# Environmental Impact Assessment Report

Appendix C3: Screening and Scoping Report and Opinion

**Grangemouth Flood Protection Scheme 2024**  
**Falkirk Council**

ENVIRONMENTAL IMPACT ASSESSMENT:  
SCREENING / SCOPING REPORT

Cell 1: Mungal Riverside

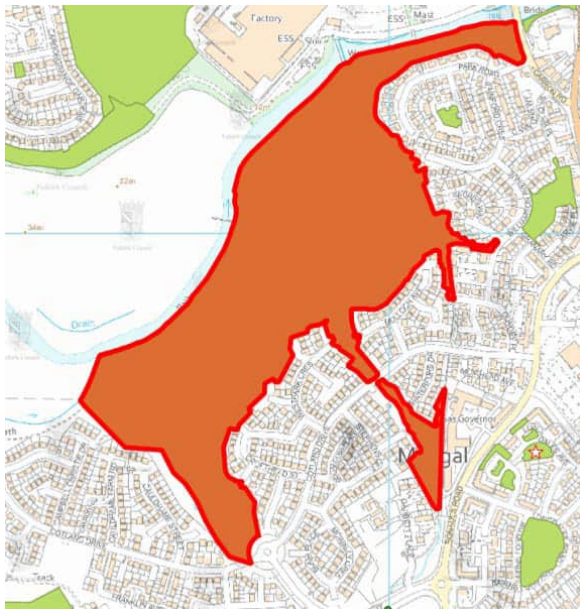
The open space section seems limited to identifying (at table 4.1) the open spaces impacted by flood defence proposals. The following open spaces (coloured in red) should be added to this table:
